E5063A-16

Modification Recommended Service Note

E5063A ENA Series Network Analyzer

Internal circuit short of A3 board

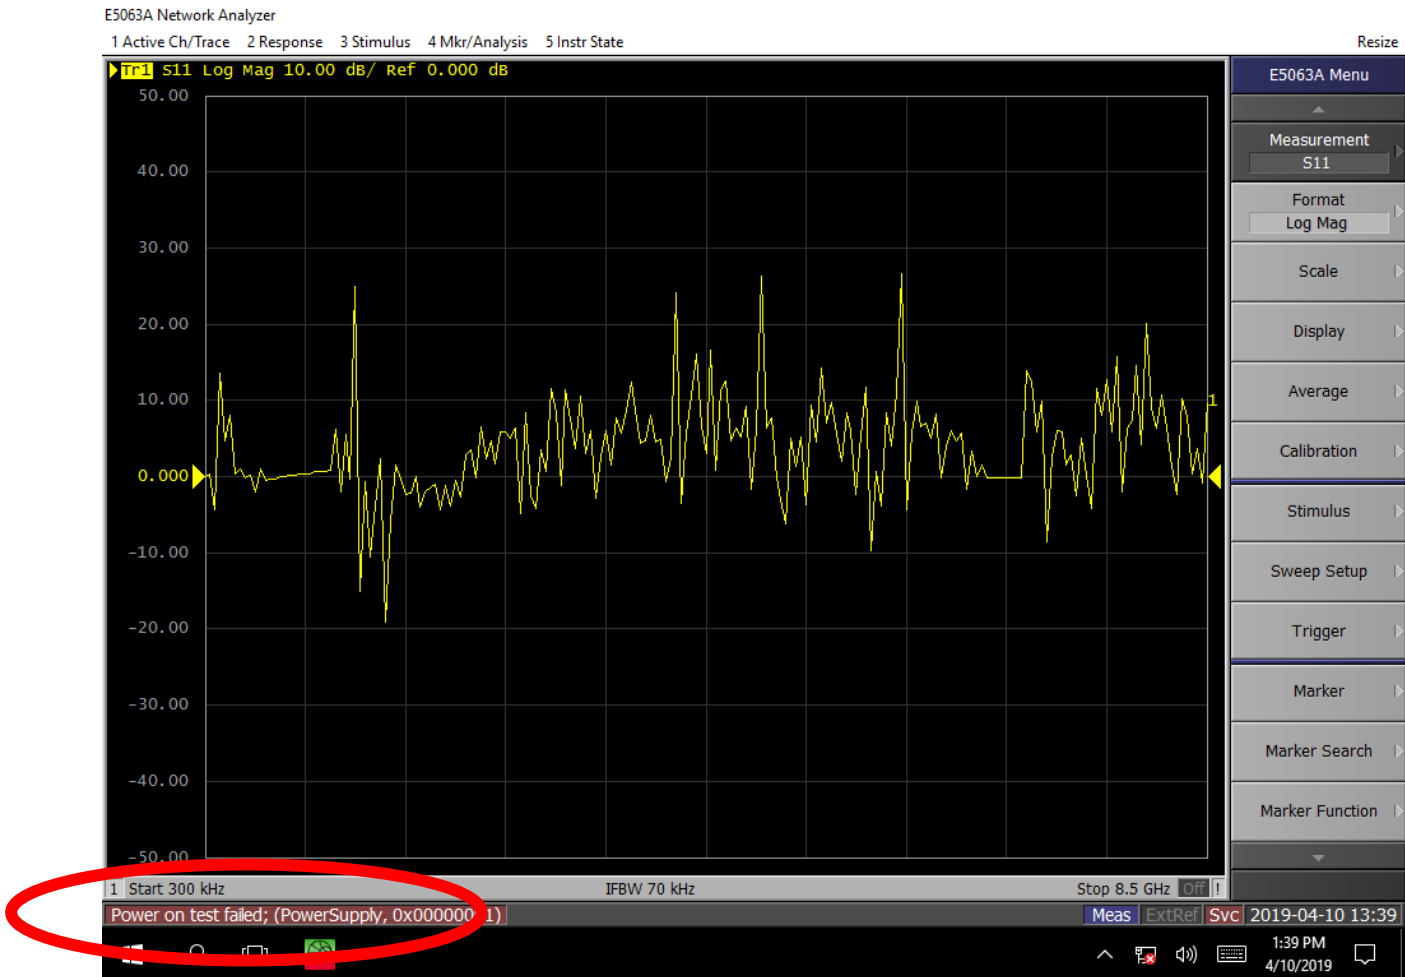
Power on test failure, PLL Unlock or the other A3 related failure happens due to internal circuit short of A3 analog main board. This failure symptom tends to appear in the high temperature and tends to disappear in the low temperature.

See below as a sample failure symptom.

Replace A3 analog main board, though the failure symptom appears intermittently. (This means if customer reported failure symptom is attributed to A3, replace A3 even though MSD cannot reproduce the failure symptom)
Perform After repair calibration.
